On April 7, 2022 the Town of Bluffton Historic Preservation Commission approved the Certificate of Appropriateness to allow the construction a new 1.5 story single-family residence of approximately 4,120 SF and a Carriage House structure of approximately 1,188 SF located at 27 Bridge Street, in the Old Town Bluffton Historic District and zoned Neighborhood Conservation-HD (COFA-05-18-011989) with the following conditions:

Following the approval, an amendment application to add wood railings and gate to the front porch, change all double hung windows to casement windows (materials, size and location to remain as originally approved). As these items do not substantially alter the approval issued by the HPC, Town Staff as stamped revised sheets A3.0, A3.1 and A3.2 received 7/5/2024 and issued the amendment.

Re: Amendment Submittal for Nerhus Residence COFA-05-011989

THE NERHUS RESIDENCE  
27 BRIDGE STREET  
BLUFFTON, SC 29910

MINOR  
EXTERIOR  
ELEVATIONS  
A3.2

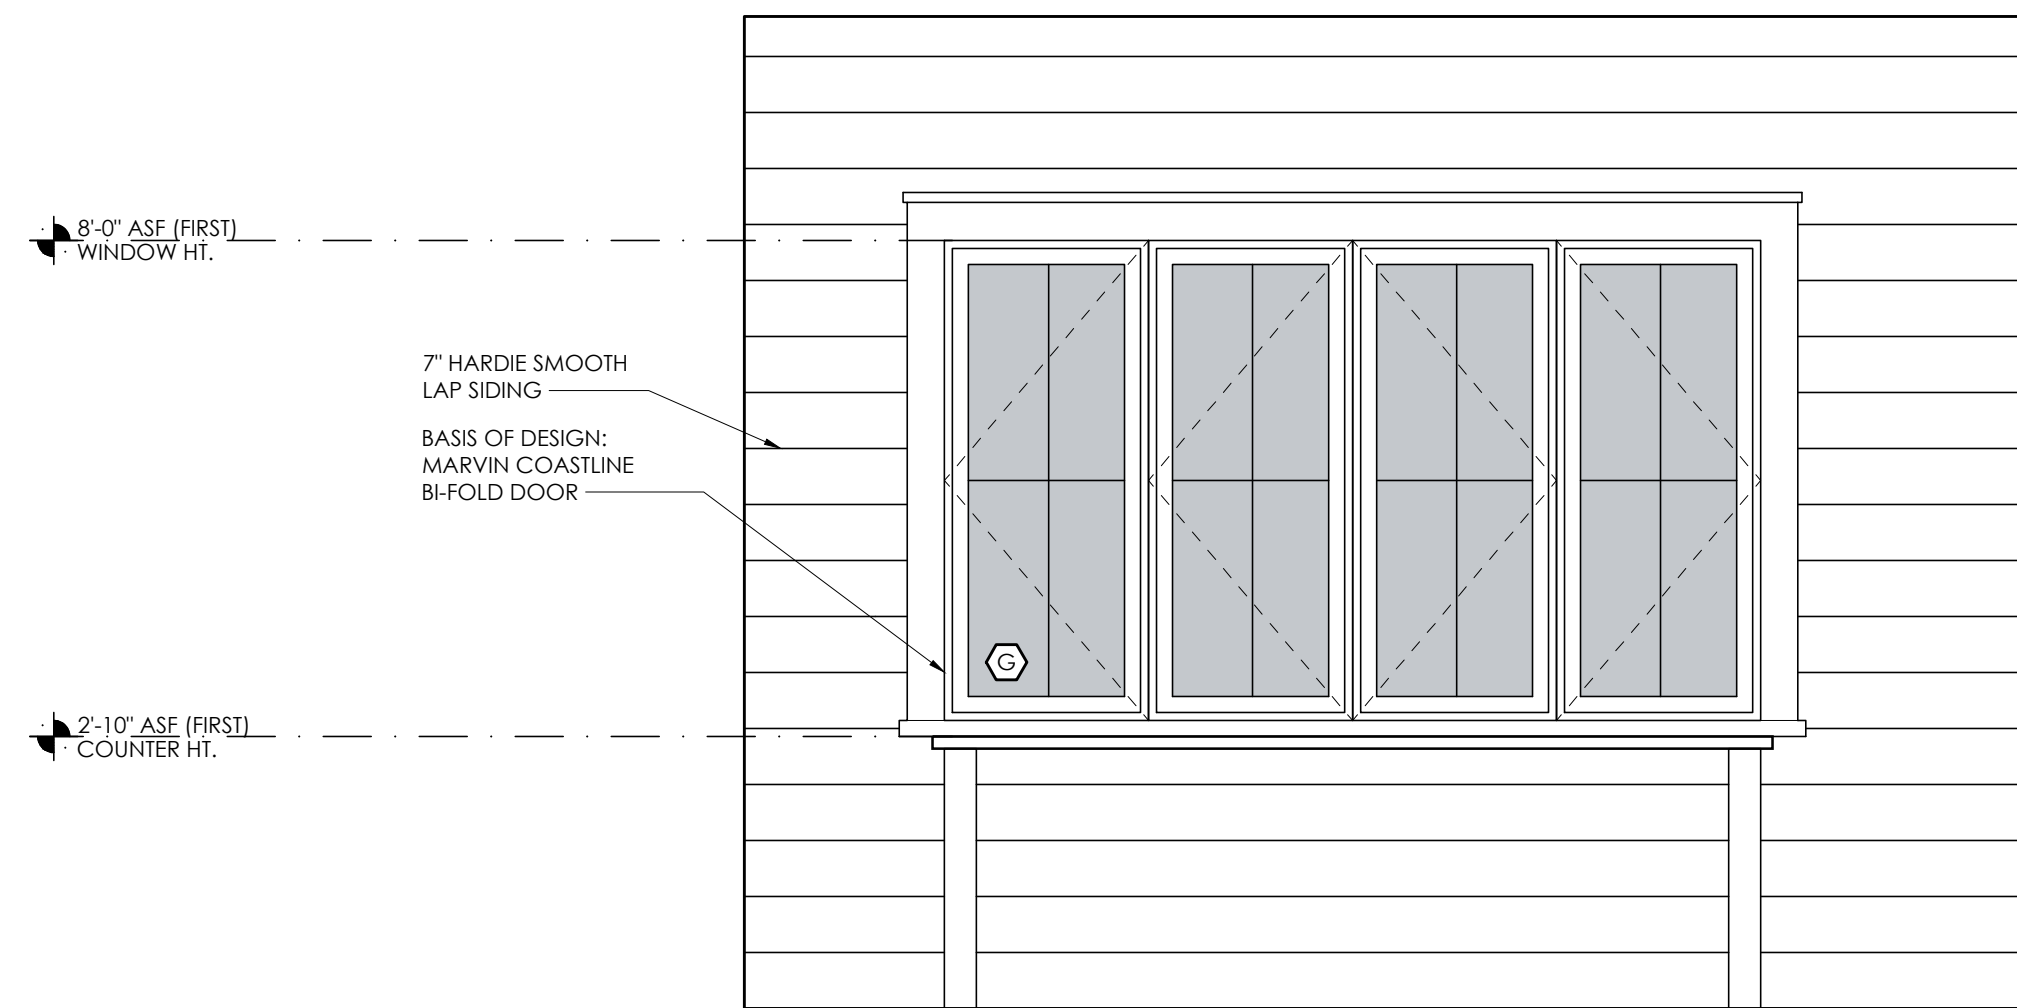
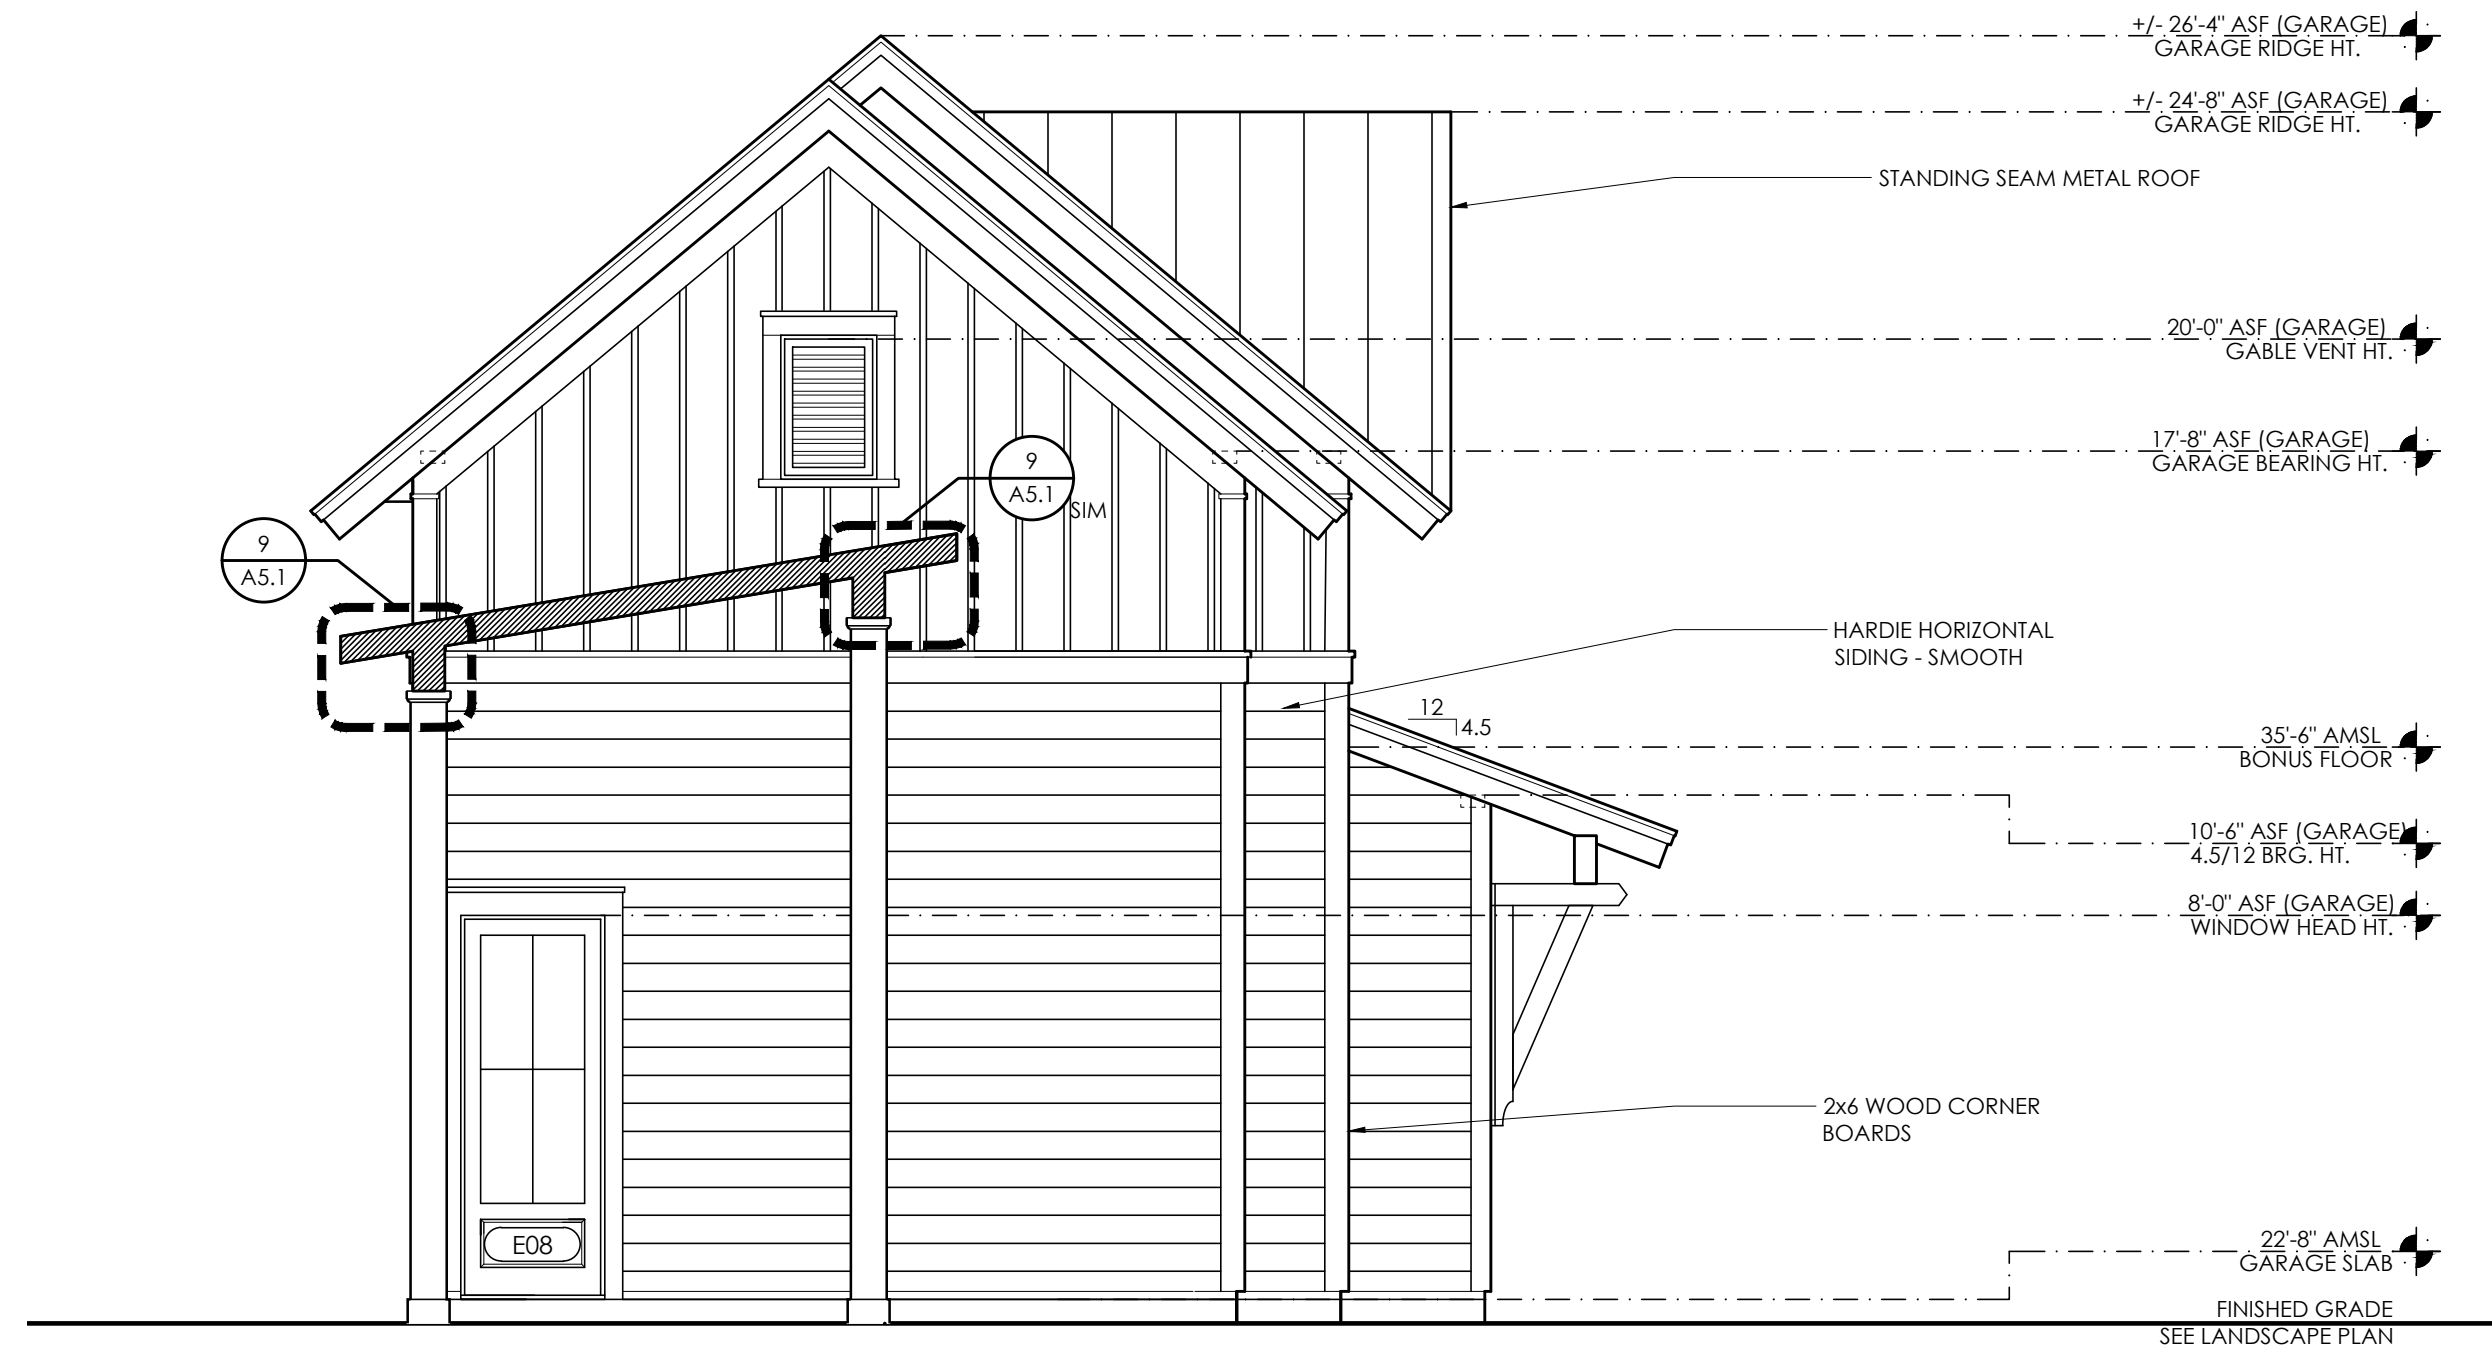
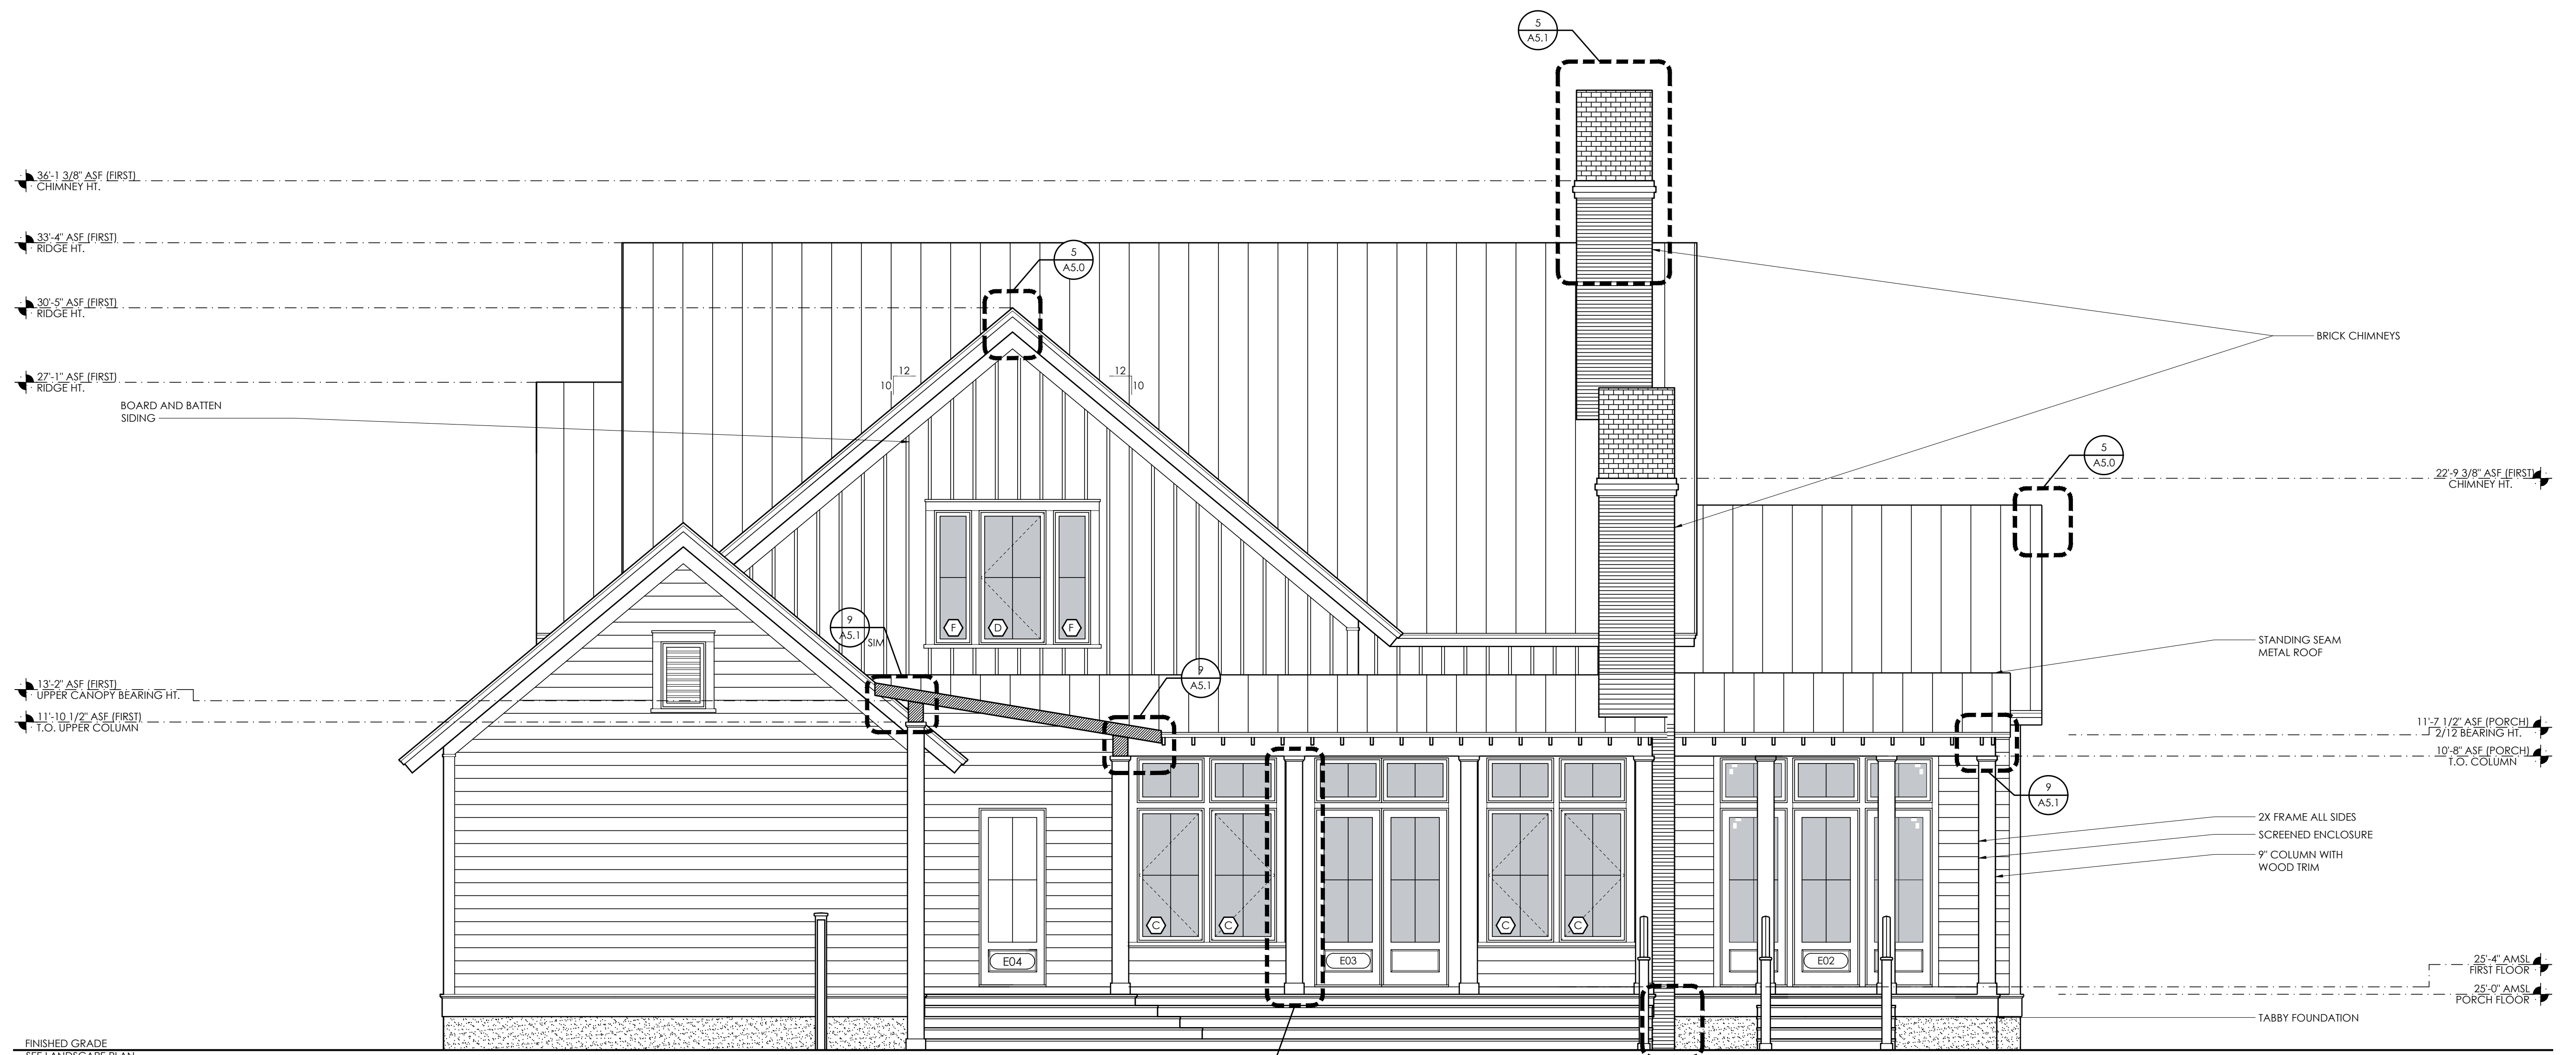
Please see attached documents for an amendment to the Nerhus Residence. Documents include application form and exterior elevations. Changes being submitted for review and staff approval are; adding to wood railing and gate to the front porch and changing out all double hung windows to casements windows (window opening / sizes and locations to remain the same and window material to be vinyl clad). If you have any questions or need any additional information please let me know.
